ADC PARKS & GREENSPACE ARBORICULTURE

PLANNING APPLICATION: AB/57/15/PL

ADDRESS: Land r/o 74-76 Canada Road Arundel BN18 9HY

BRIEF DESCRIPTION: Erection of 2No 3.Bed semi-detached houses,
associated car parking & erection of a car port

Figure 2 Default specification for protective barrier

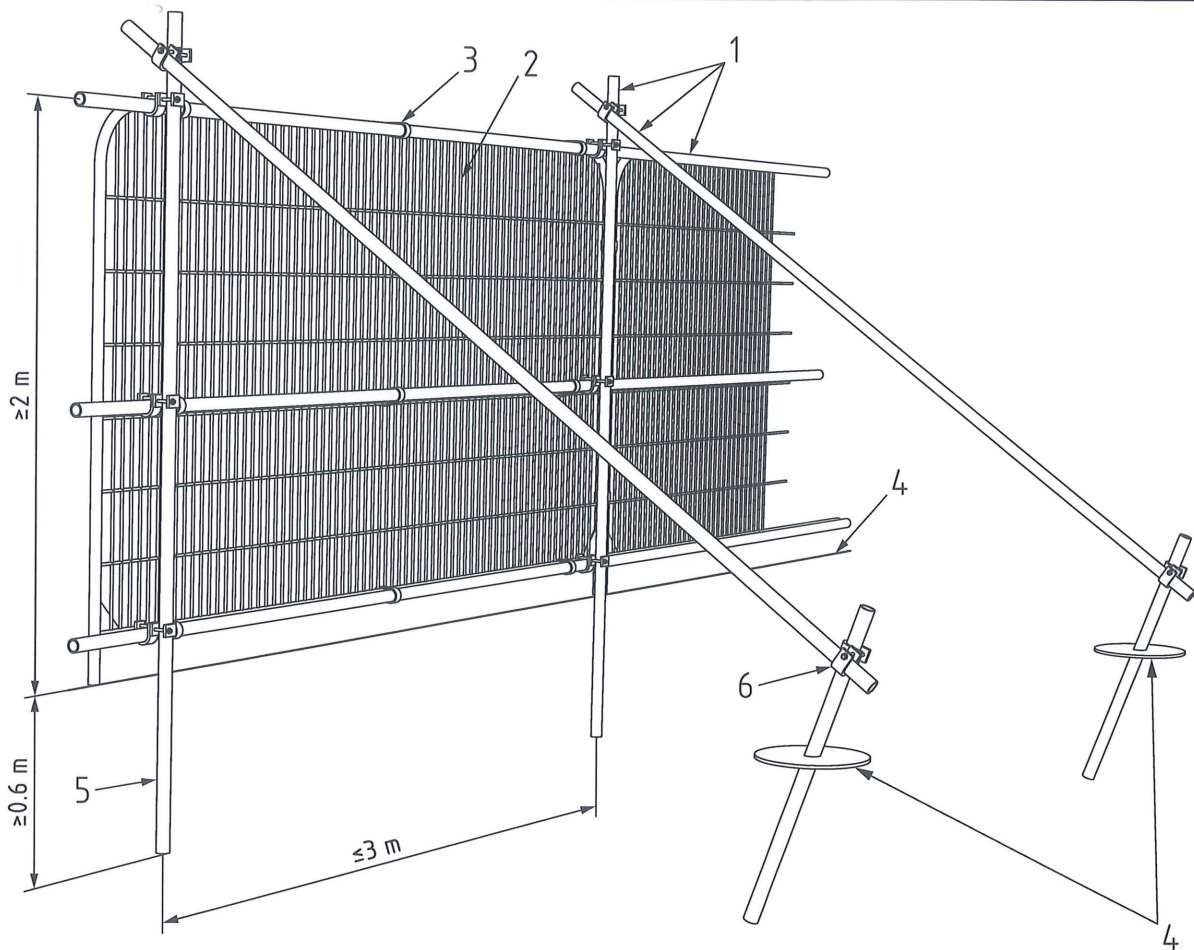
- If any root structure is excavated with a diameter over 25 mm, then the ADC tree officer must be informed, so a site visit can be conducted.
- All methodology for working within the RPA cited in the submitted arboricultural report is adhered to.
- All cited RPA fencing/protecting must be installed as to meet the methodology as stated in the submitted method statement.
- All pruning operations are to meet the standards as set in the BS 3998 2010.
